PLANNING REVIEW

Revised PRO Concept Plan: Consideration of Eligibility

Rezoning Request from OST Office Service Technology to Low-Density Multiple Family RM-1 with a Planned Rezoning Overlay

Review Date: September 1, 2023
Review Type: PRO Concept Plan – Revised Initial Submittal
Project Name: **JZ22-28 Elm Creek PRO**
Location: West of Meadowbrook Road, South of Twelve Mile
Plan Date: June 21, 2023
Prepared by: Lindsay Bell, Senior Planner
E-mail: lbell@cityofnovi.org; **Phone:** (248) 347-0484

SITE PLAN - PHASE 2

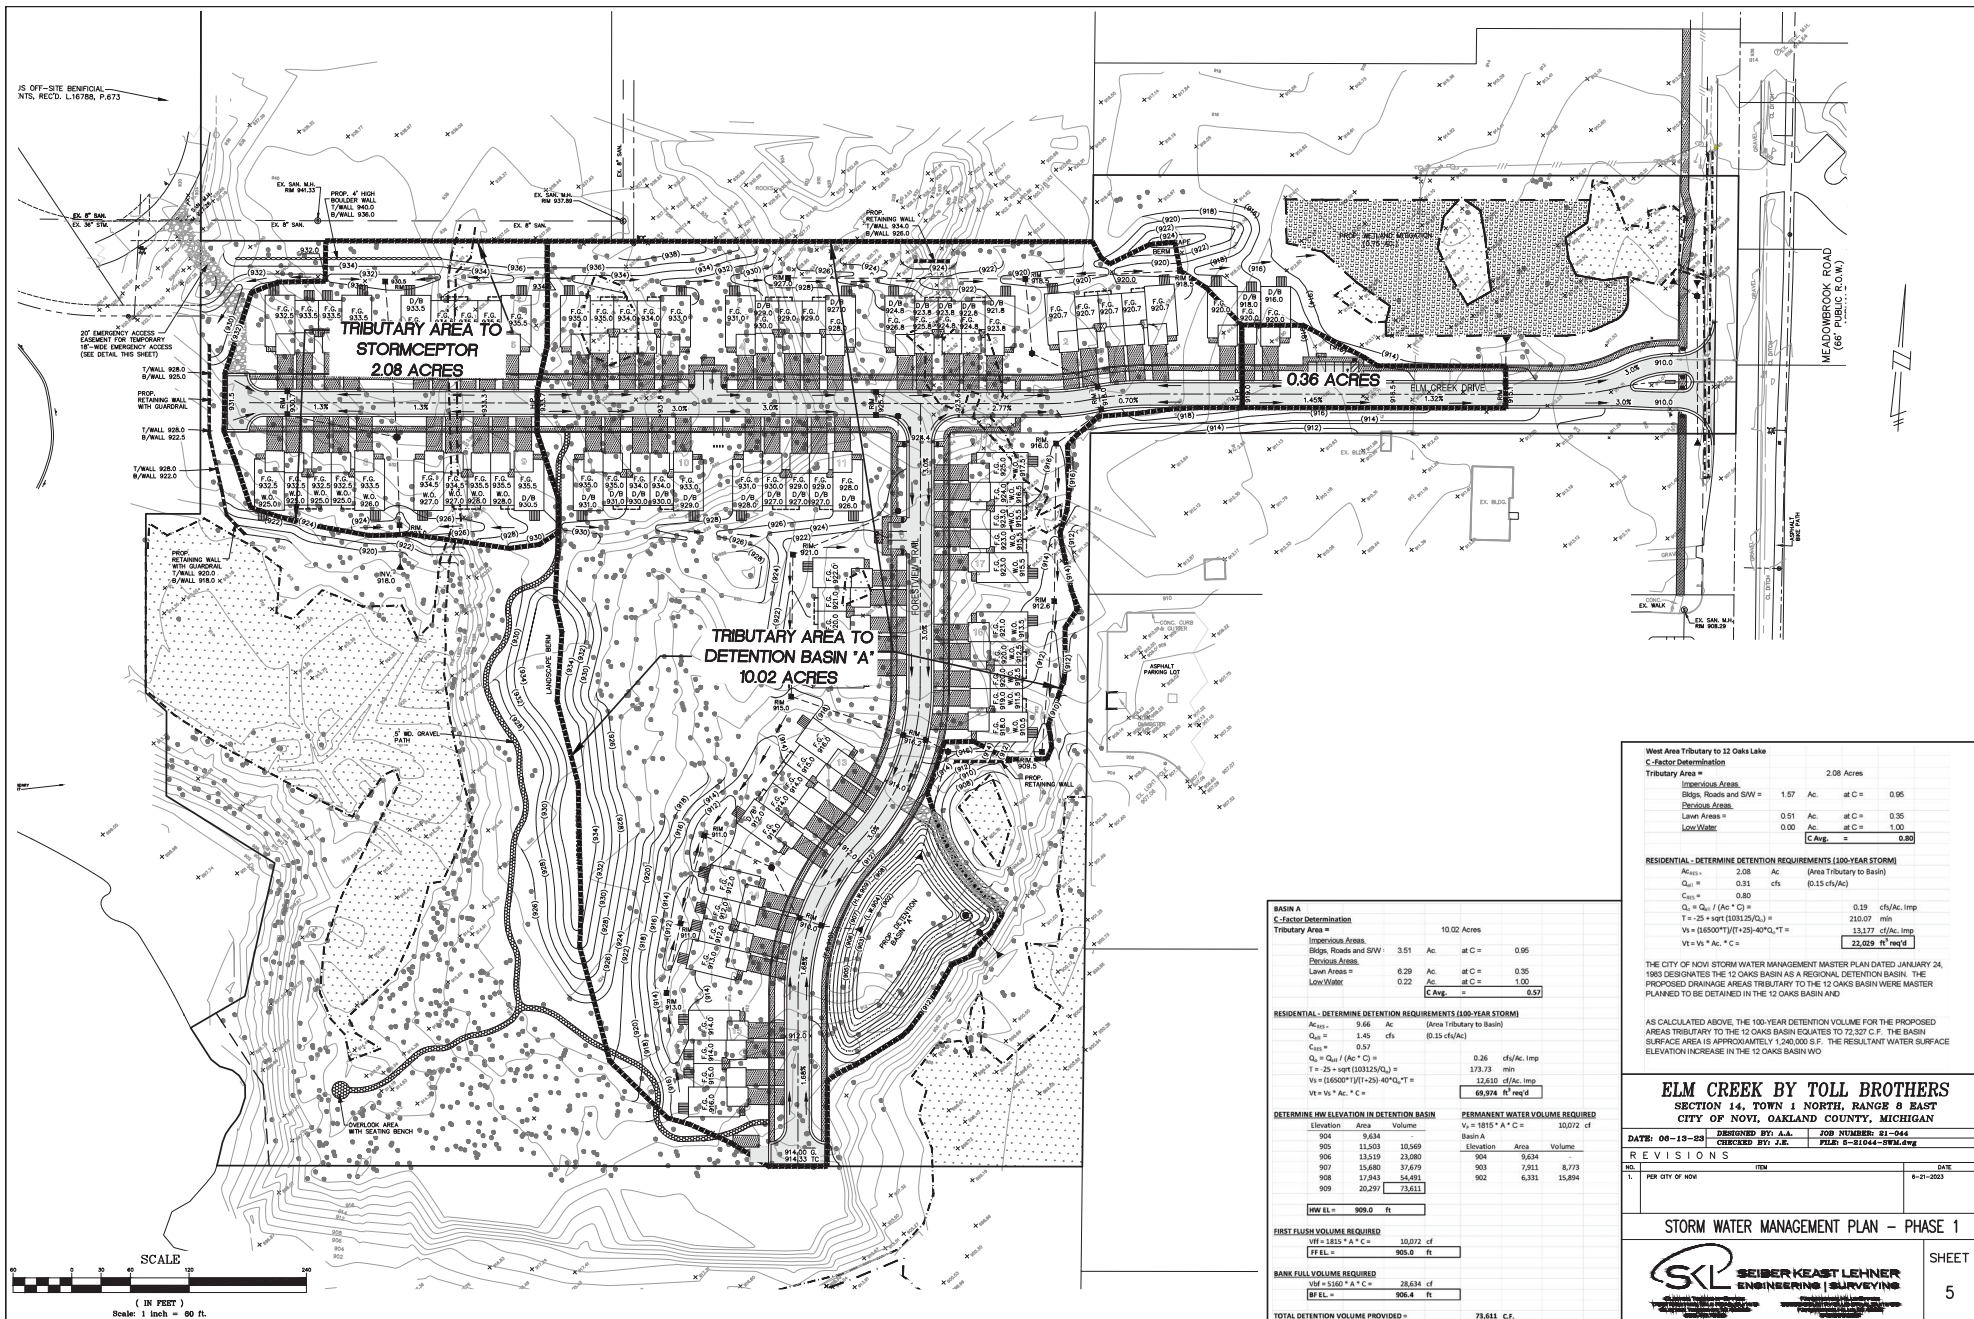
Another concern is that very little detail is provided for the “Phase 2” area of the project. No boundary/topographic survey is provided for the southern area (ie, that area owned by Singh), and no tree survey is provided. The proposed plan for the southern area is very conceptual.

similar looped pathway is also proposed for the Phase 2 portion, however the exact area included in the calculation is not shown on the plan.

SHEET		
5

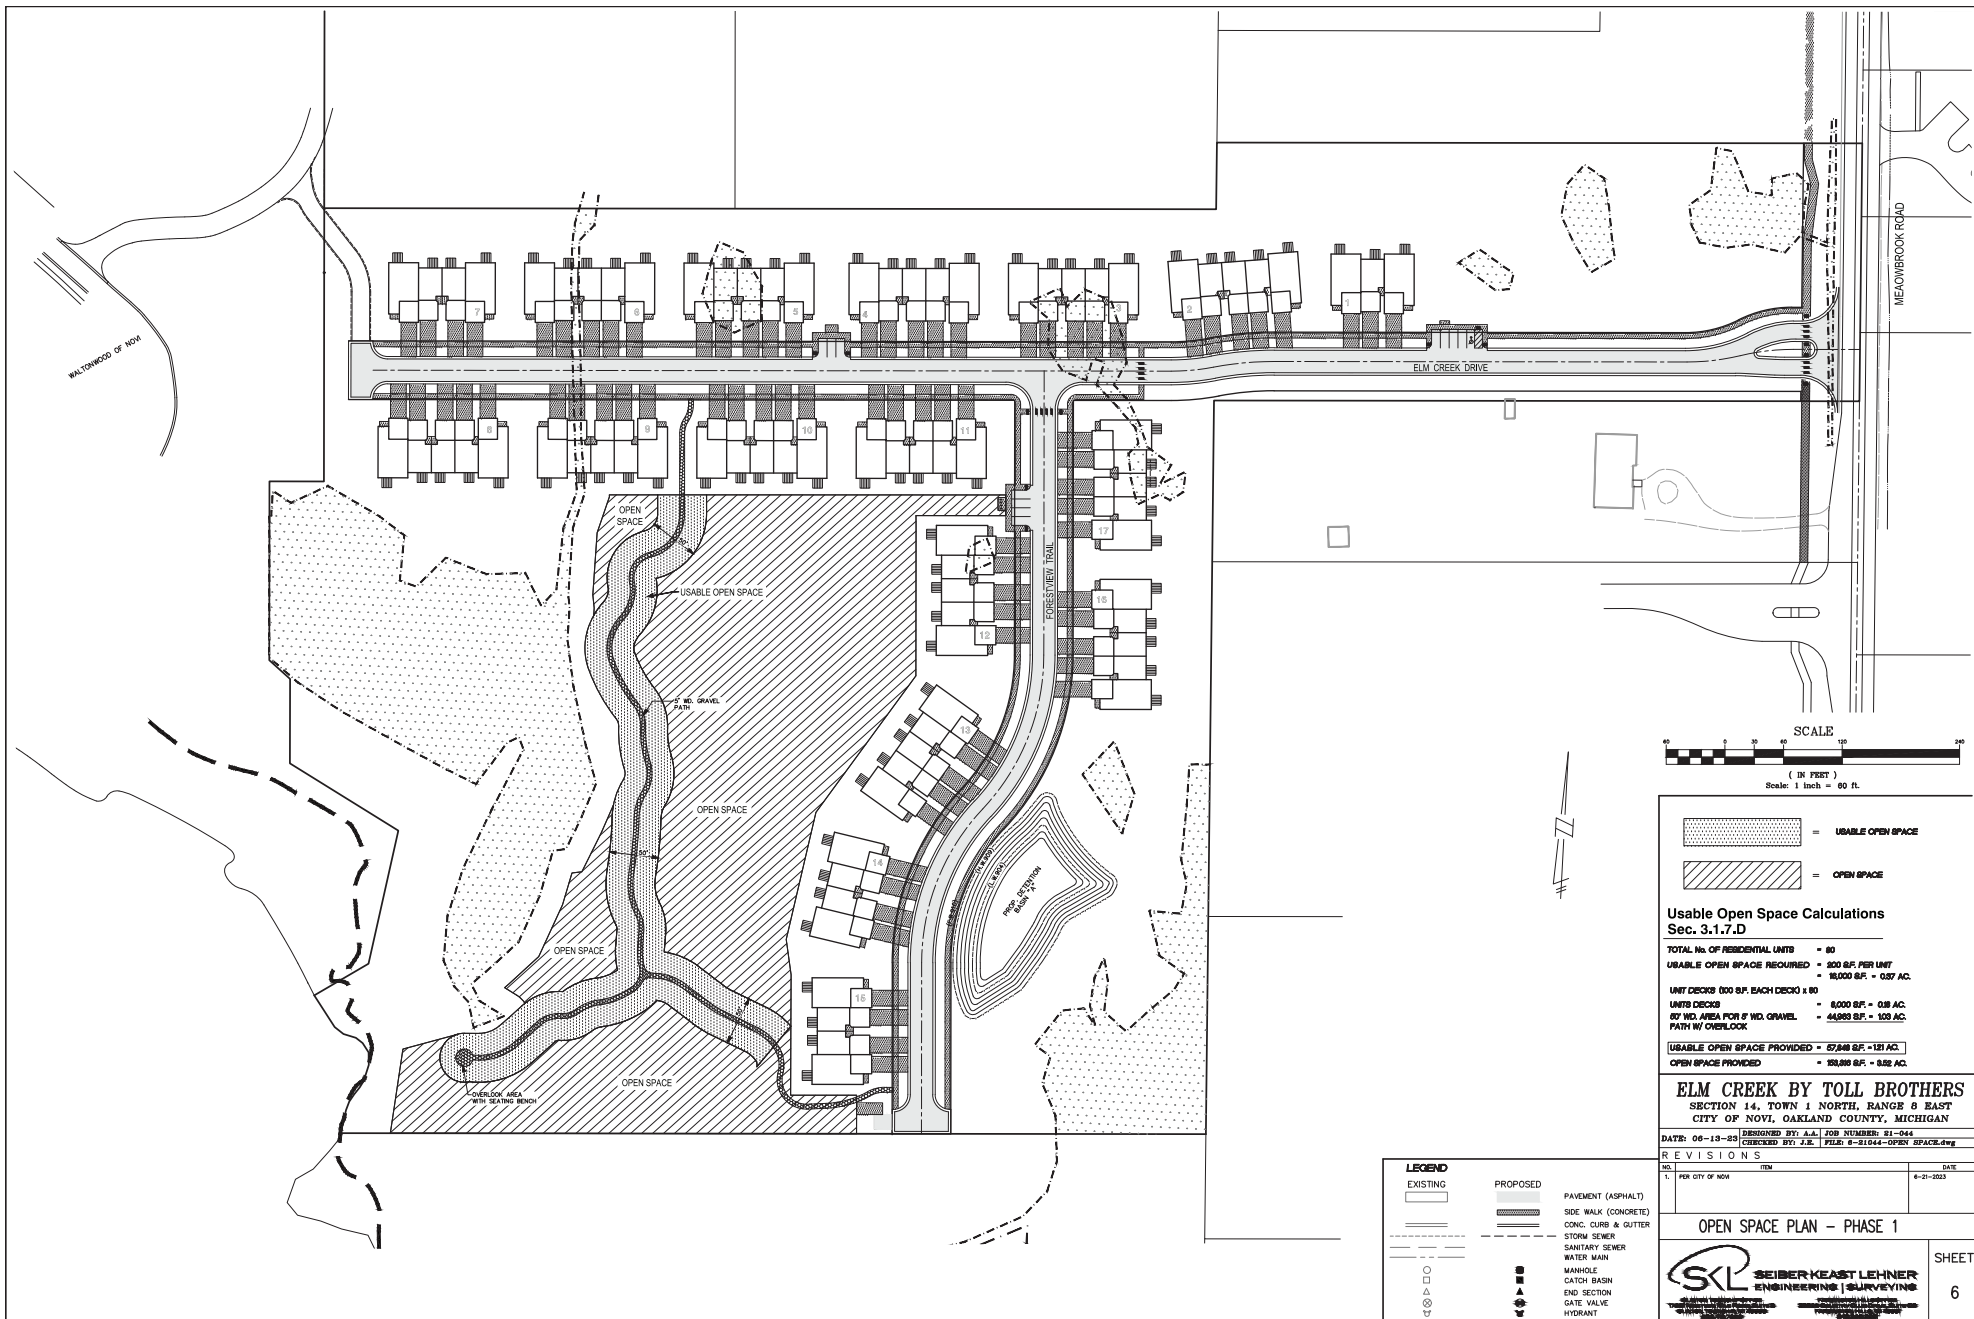
38. The contour lines on plan Sheet 4 shows different elevations than Sheet 5 (south side of the property). It appears Sheet 4 is correct.
39. Provide at least 3-foot of buffer distance between the sidewalk and any fixed objects, including hydrants and irrigation backflow devices. Include a note on the plan where the 3-foot separation cannot be provided.

EMERGENCY VEHICLE ROUTE

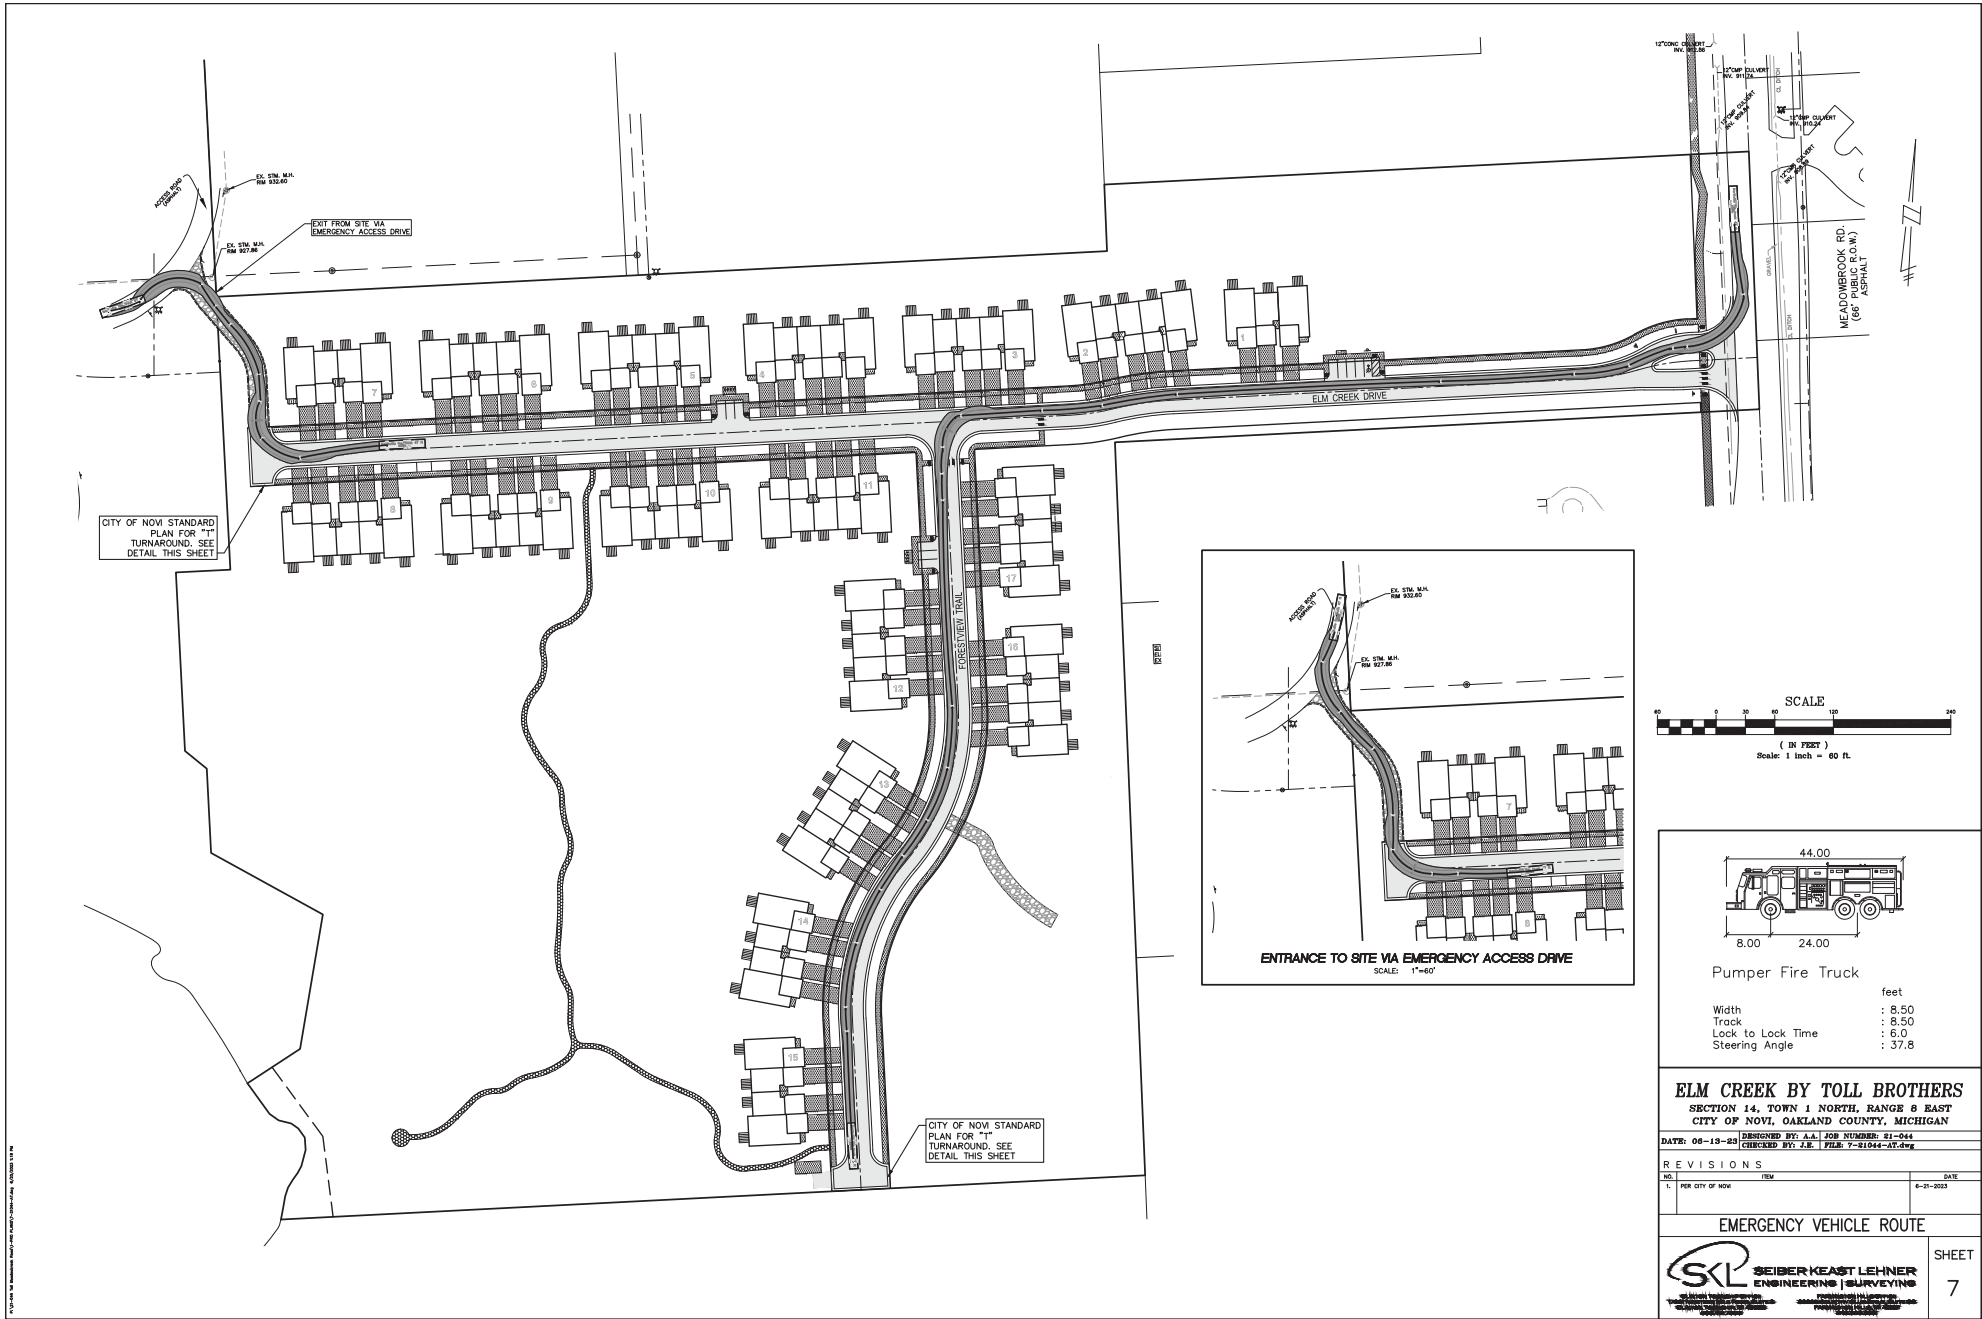
- There is no secondary access for emergency vehicles in case the entrance from Meadowbrook Road is blocked. **The Concept plan now proposes an emergency access only route on the northwestern side of the site, which would connect to an existing emergency access on a neighboring property. Off-site easements will be required.**
